SI M17 05 12
Cooling Systems

Service Action: Retrofit of the Engine Coolant Temperature Sensor

R60 with automatic transmission (N16 or N18 engine)

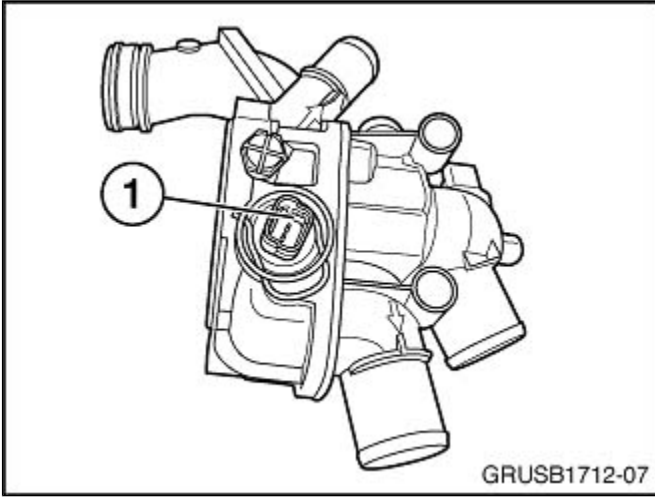
NEW **Procedure Two** requires the installation of a new engine temperature sensor, with integrated wire harness, installed in place of the thermostat bleeder screw.

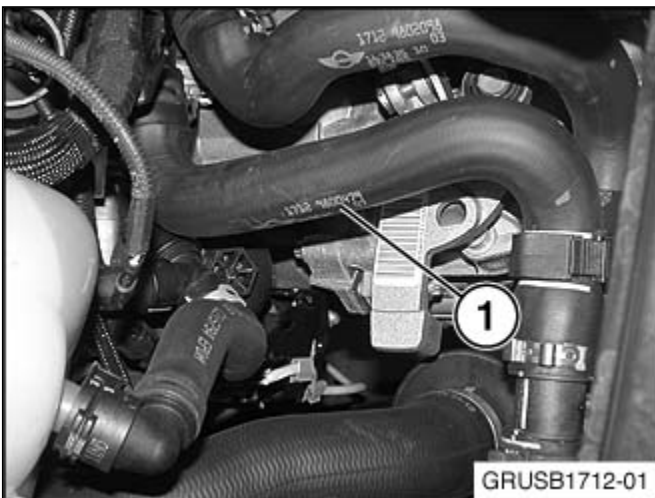
Checking for the updated thermostat:
The 11 53 7 534 521 thermostat has a replaceable engine temperature sensor (1).

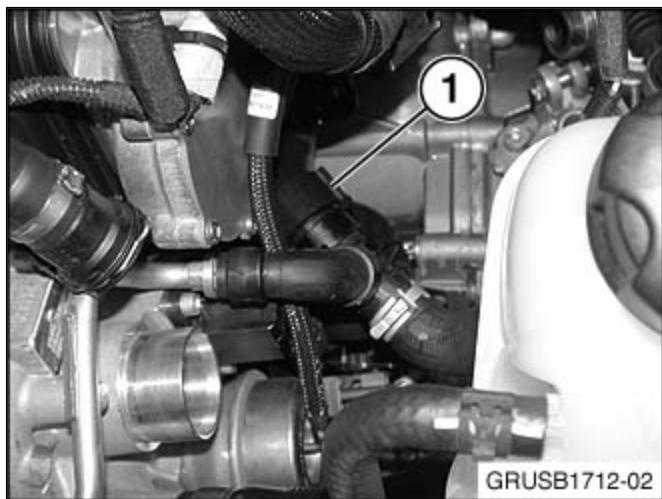
Remove the coolant hose (1). This hose will not be reused.

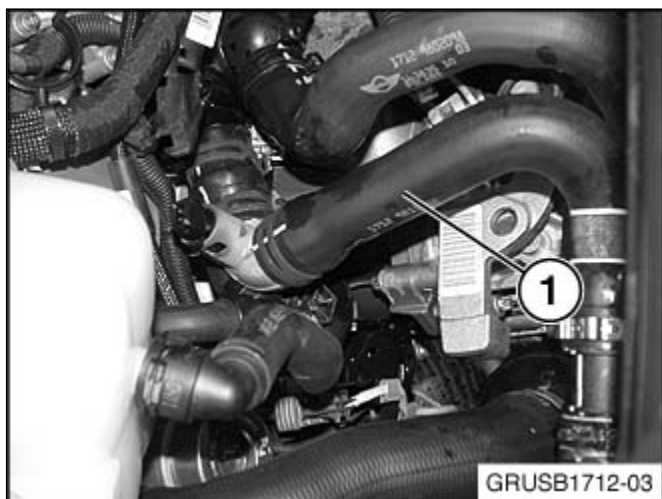
N18 engine only! Install spacer P/N 64

53 7 578 707 (1) on the coolant line as shown.

Note: The spacer needs to stay in this position when installing the new coolant hose P/N 17 12 9 811 351 (next step).

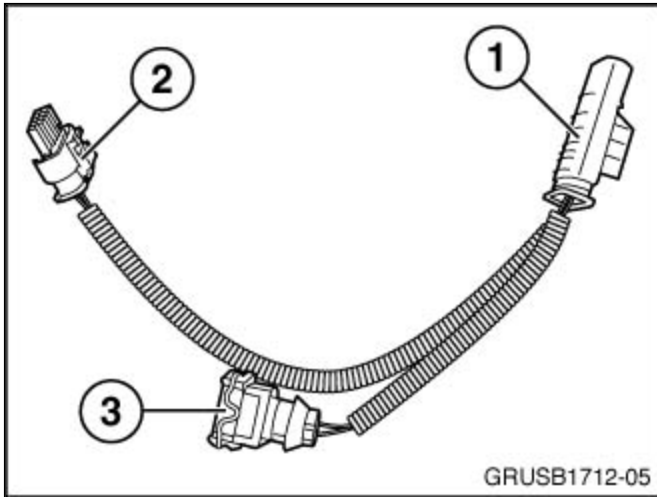
Install the new coolant hose with sensor P/N 17 12 9 811 351 (1).

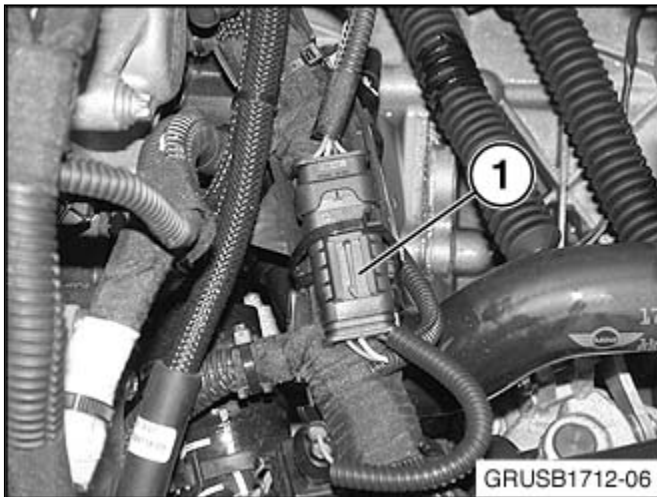
Unplug connector X6279 from the engine thermostat (1).

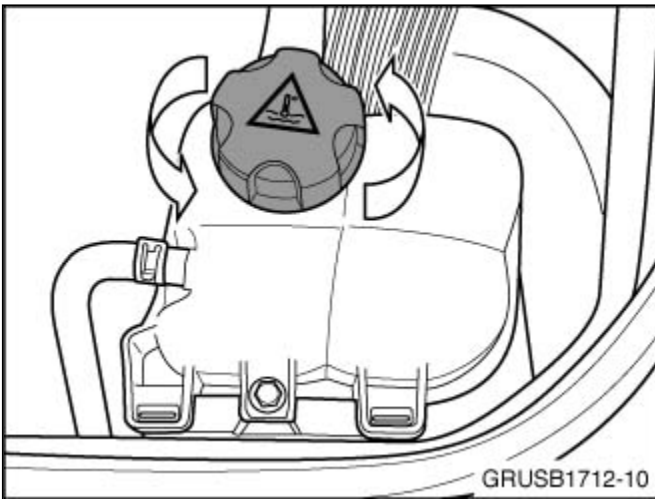
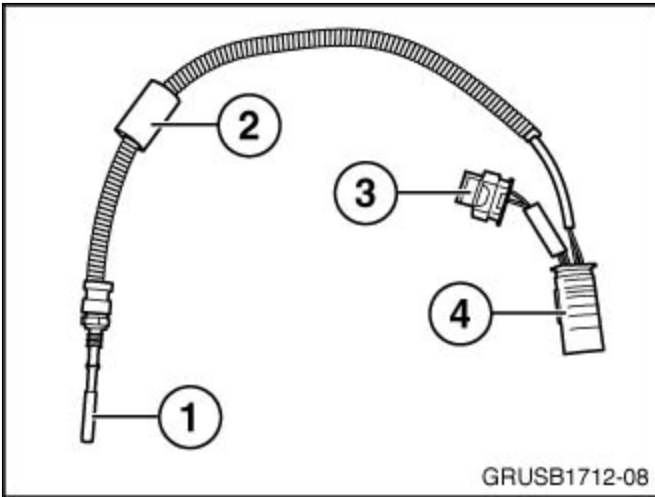
Plug connector X6279 into the 4-pin male connector (1) of adapter harness P/N 12 51 7 647 200. Insert the 4-pin female connector (2) of the adapter harness into the engine thermostat. Plug the 2-pin female connector (3) from the adapter harness into the engine temperature sensor of hose P/N 17 12 9 811 351.

Secure the connector (1) with a cable tie to the engine wiring harness.

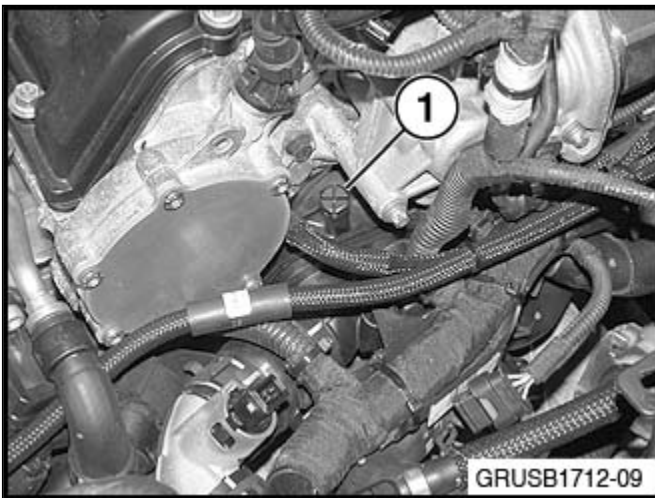
The improved sensor (P/N 13 62 8 603 908) includes the temperature probe (1) and insulating sleeve (2), a two-pin female connector (3) for the map thermostat, and a four-pin connector (4) for the engine harness.

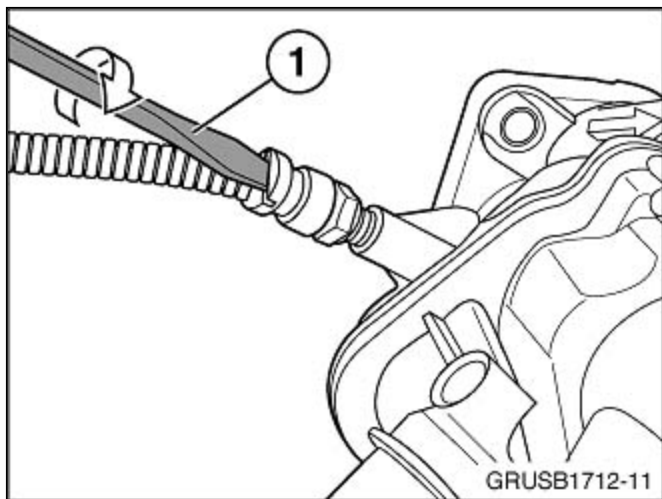
Relieve the coolant pressure by removing the reservoir cap, and then re-tighten.

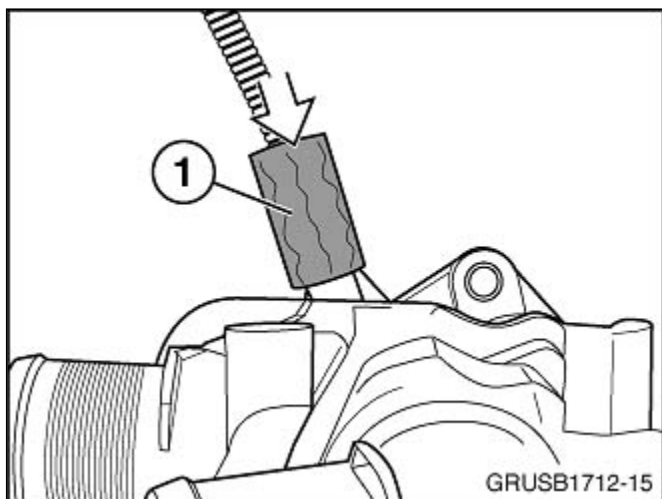
Remove the bleeder screw (1) from the thermostat. This screw will not be reused.

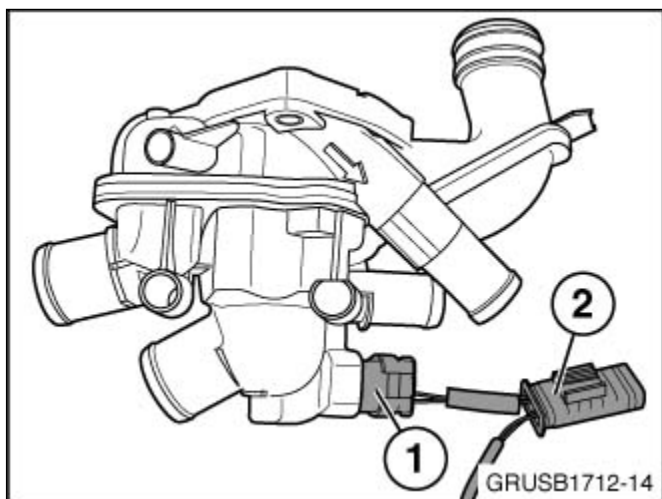
The back of the temperature sensor is slotted to accept a bladed screwdriver (1). Install the sensor into the bleeder screw hole, and torque to 2Nm.

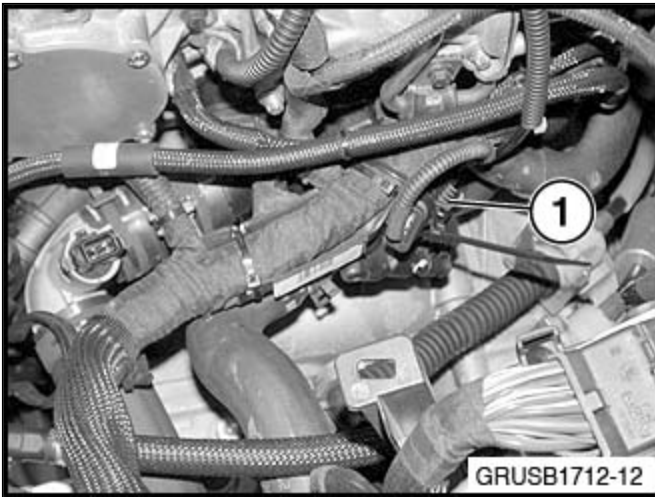
Slide insulating sleeve (1) onto the temperature sensor. The sleeve must completely cover the sensor.

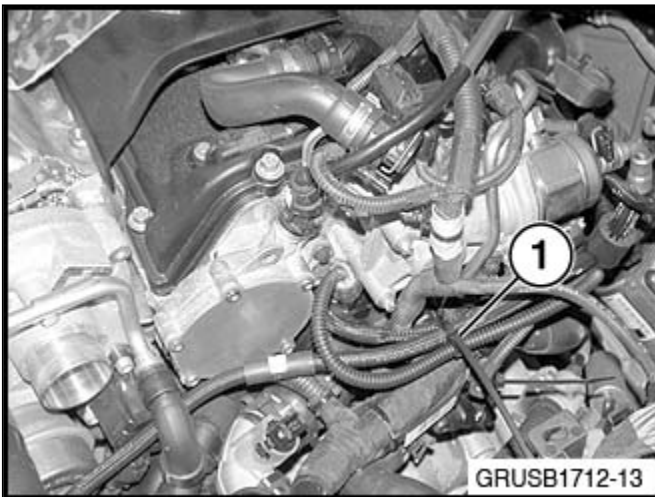
Install the two-pin female connector (1) into the thermostat and the four-pin male connector (2) into the engine wiring harness.
